**Ref: APPLICATION FOR CONSENT UNDER SECTION 36 OF THE ELECTRICITY ACT 1989 (AS AMENDED) AND MARINE LICENCES UNDER PART 4 OF THE MARINE (SCOTLAND) ACT 2010 TO CONSTRUCT AND OPERATE INCH CAPE OFFSHORE WINDFARM (REVISED DESIGN), 15KM EAST OF THE ANGUS COASTLINE**

### **Inch Cape Offshore Windfarm Revised Design – Consultation**

### **INCH CAPE OFFSHORE WIND FARM (REVISED DESIGN)**

**Fig 2G.1:** Captures at sea of salmon that either returned to or came from the Tweed (excluding the N. E. England net fisheries)

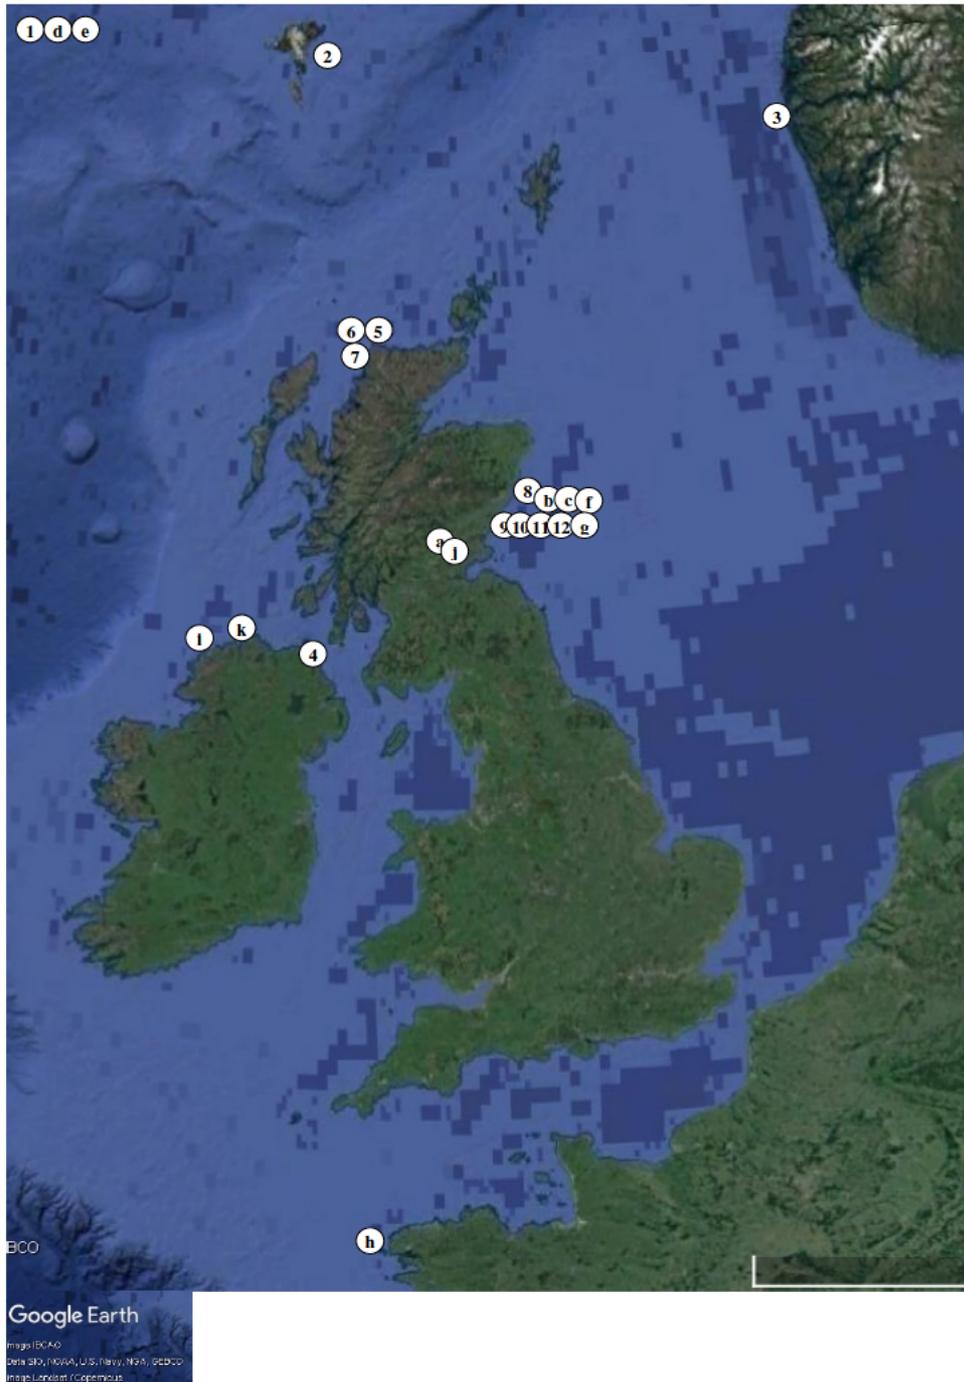
The application for this development has not taken into account the fact that a large number of East coast Salmon travel across the North Sea in line with south Northumberland, and then travel northwards up the east coast to reach their Scottish natal rivers. This has been proven to be the case by tagging studies (Malcolm et al, 2010).

This development will have a more far-reaching effect on rivers further away from the site than the developers have considered. The map below shows the recaptures of Tweed fish at sea, which shows that they have been caught in the Montrose and Aberdeen areas close to the proposed wind farm locations, through which they would have to travel if they then took a straight course to Tweed.

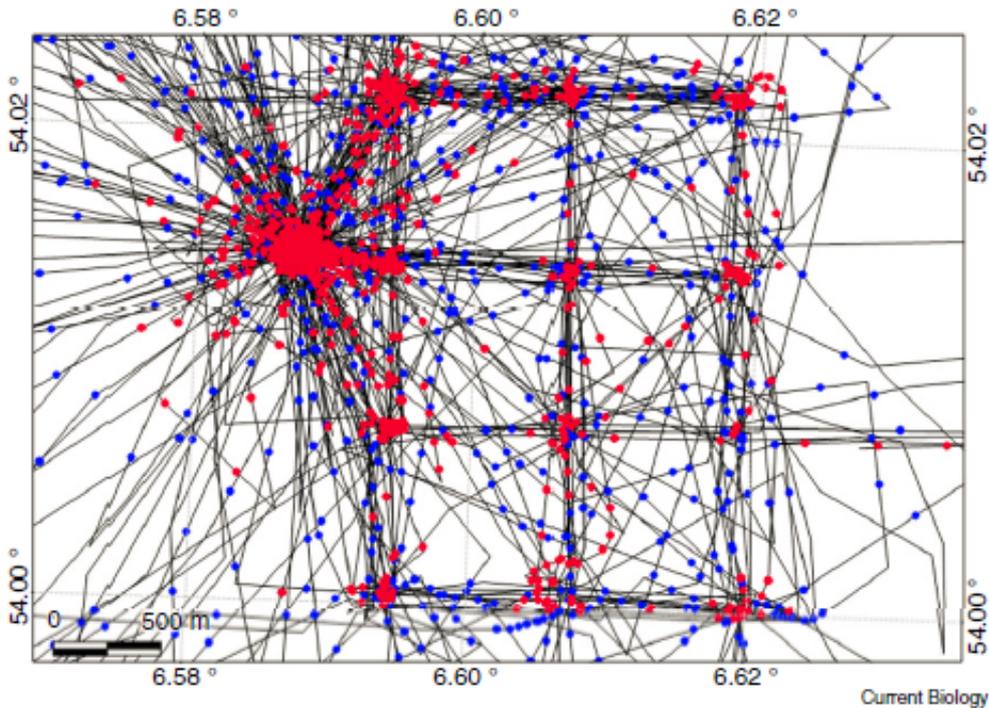
Salmon passing through the area of the proposed development are already vulnerable to predation from the large seal populations on the east coast. New information has shown that the bases of wind turbines act as artificial reefs, attracting both Gray and Harbour seals to hunt around them (*Russell et al, 2014*). Marine wind turbines are therefore now known to alter the foraging pattern of seals and attract them in to areas that they would otherwise have just passed through. The influence of underwater structures on the predation during the offshore migration of Salmon has not therefore been fully considered. The diagram taken from this

paper, below, clearly shows wind turbine to attract seals.

These authors also state: "*The finding that a proportion of seals adjust their behaviour to make use of anthropogenic structures raises questions regarding the attributes of these individuals and the ecological consequences of such behaviour.*" and "*The windfarms considered here were new, and prevalence of such behaviour may increase with time, especially if the artificial reefs are not yet fully established. Even at the levels of prevalence within our sample, this behaviour is likely to be displayed by a large number of individuals given that the population of Harbour Seals in the North Sea is estimated as 55,000 and 65,000 Gray Seals are estimated to haul out on the British coast of the North Sea alone.*"
